Building Permit Application

Mechanical + Electrical revisions
Add Fire/Smoke dampers

12-626266-
RSN 683793
John L
CITY OF AURORA
BUILDING DIVISION
APPROVED AS NOTED JL
DATE 10/9/12

WOMEN'S HEALTH

M3.0

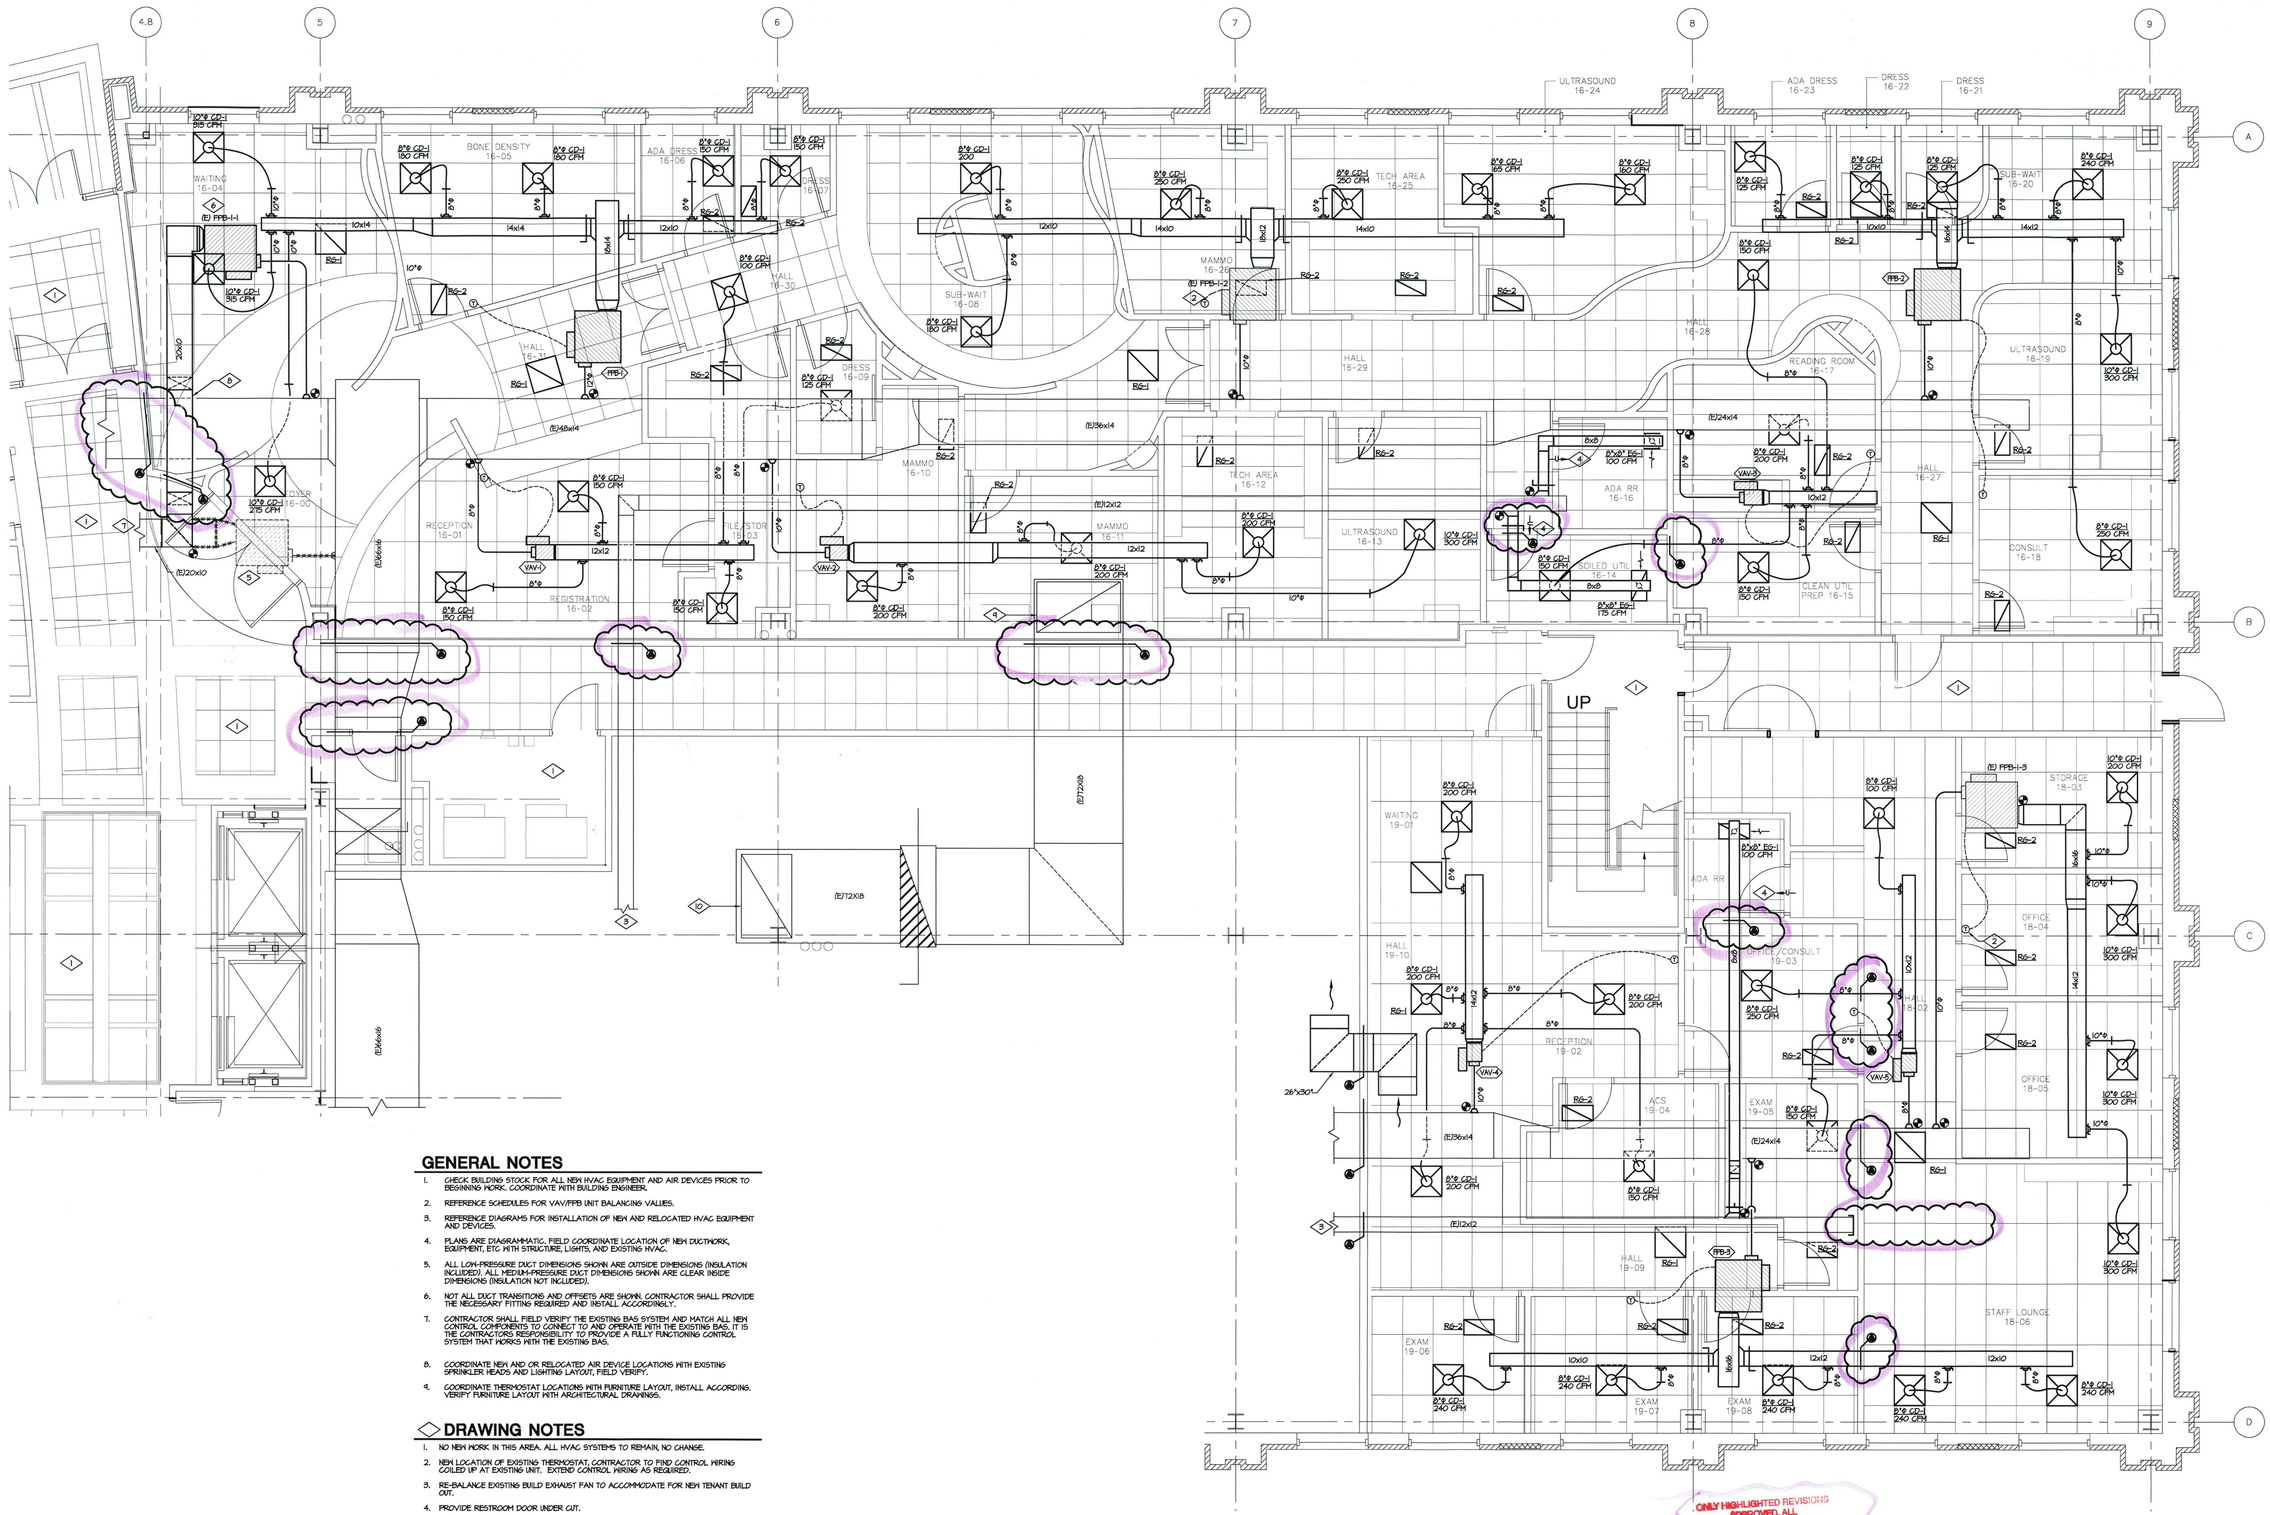
ONLY HIGHLIGHTED REVISIONS APPROVED. ALL PREVIOUS COMMENTS APPLY.

E1.0

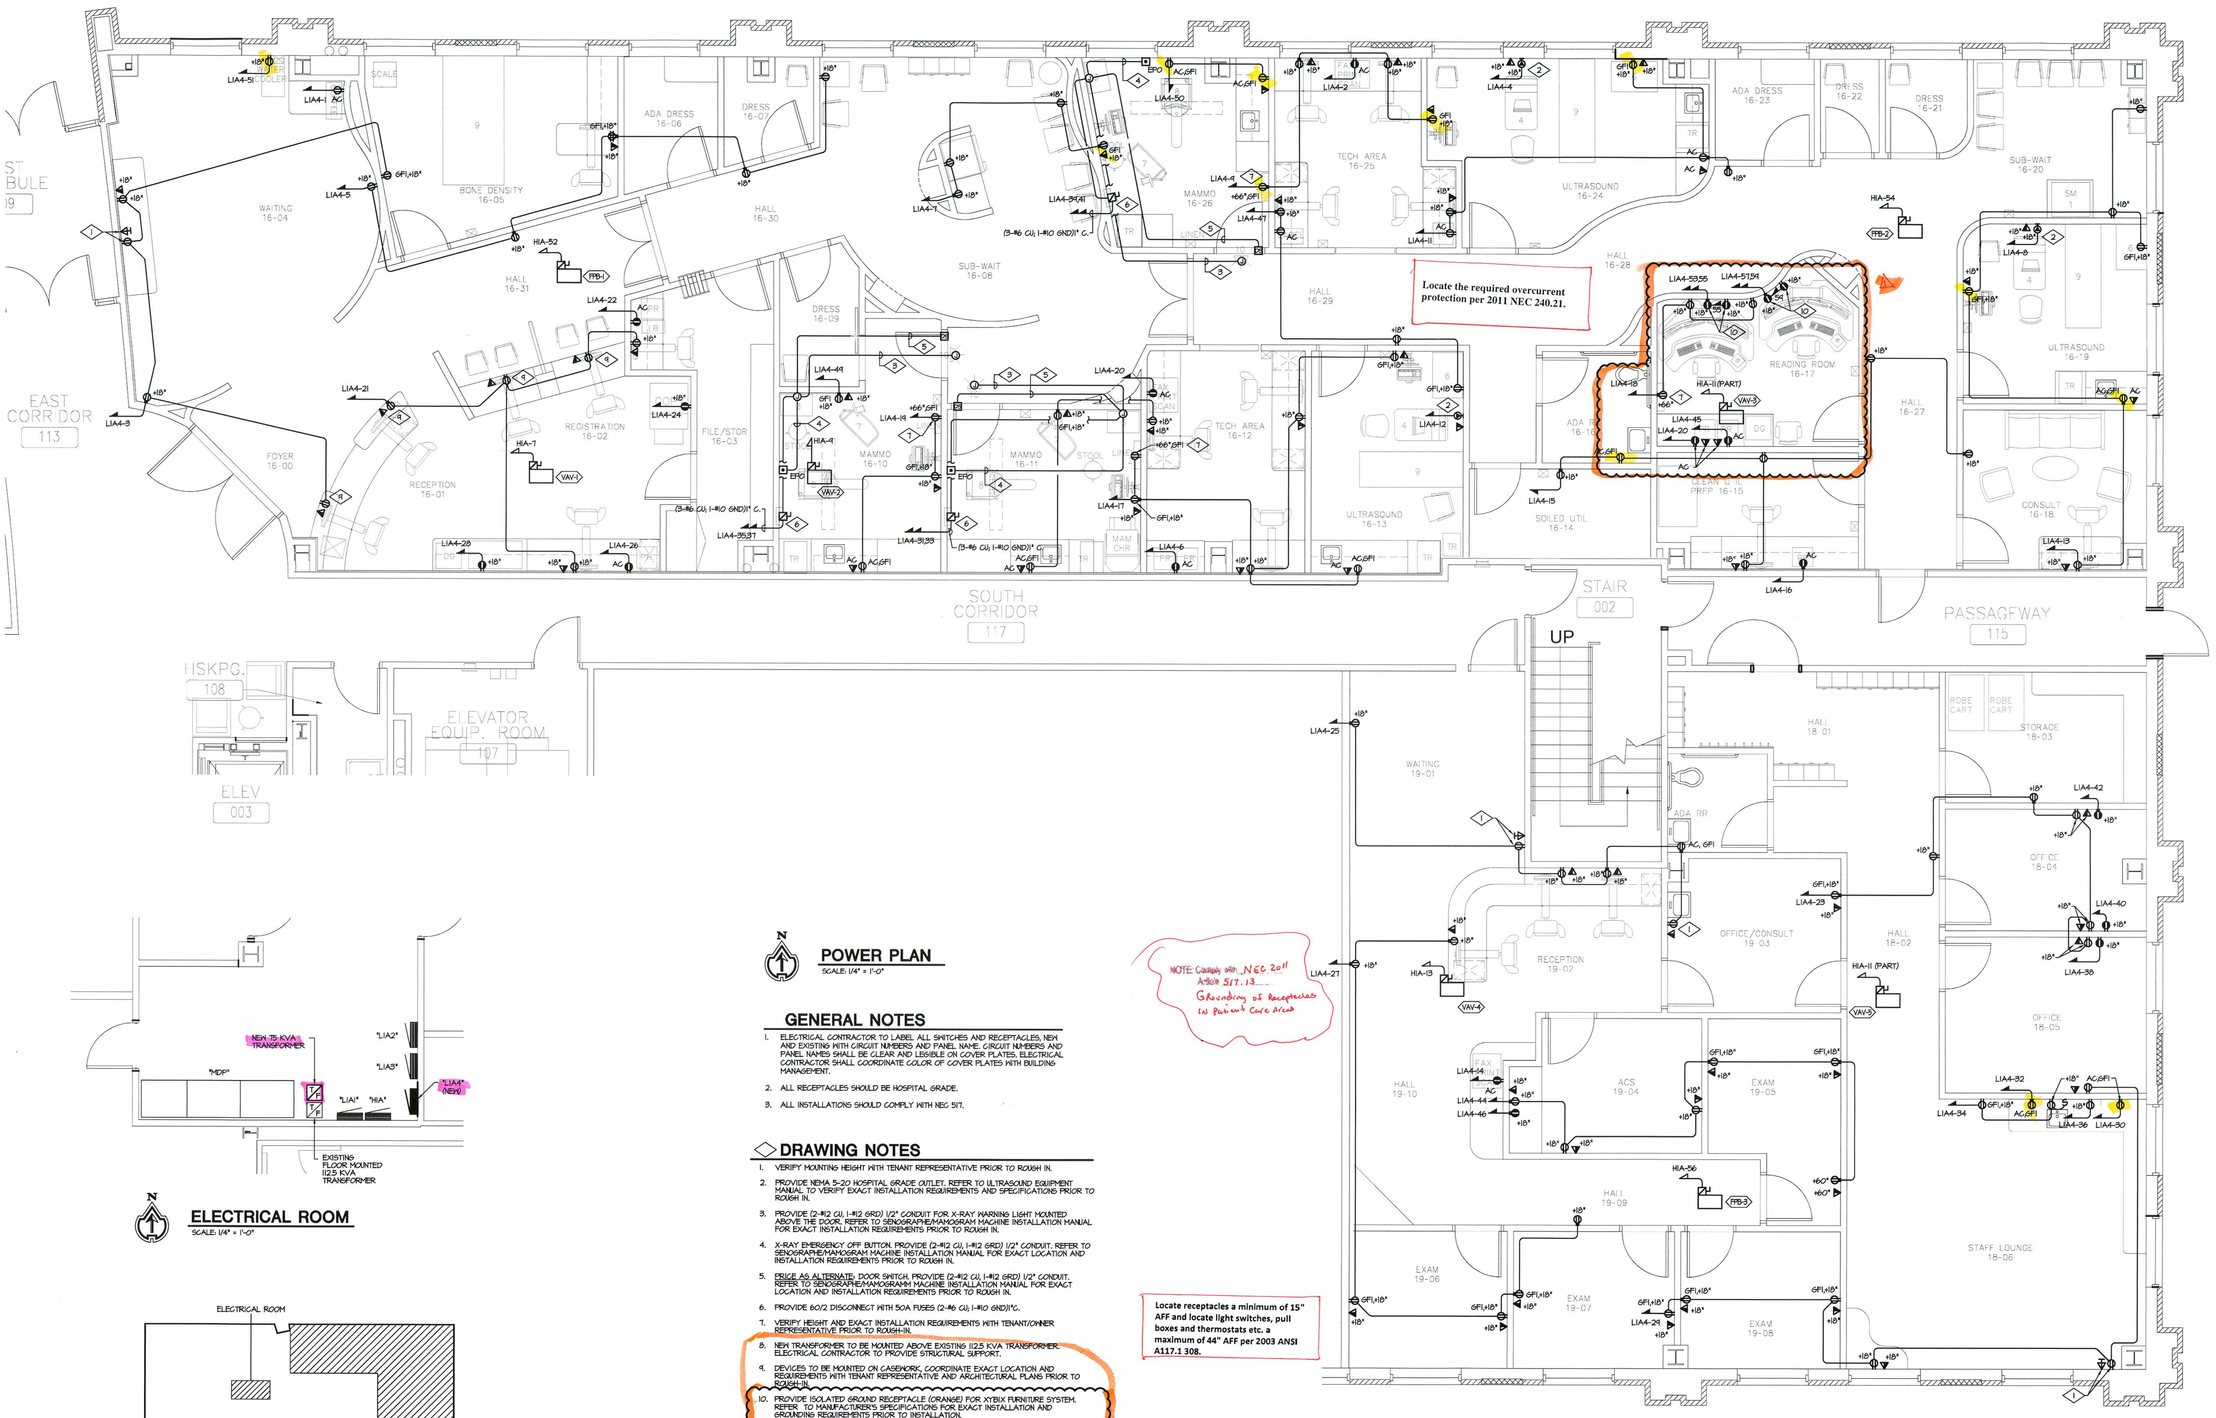
Only work covered in Permit

AURORA BUILDING INSPECTION
ELECTRICAL SECTION
APPROVED
SUBJECT TO COMMENTS AS NOTED AND FIELD INSPECTIONS
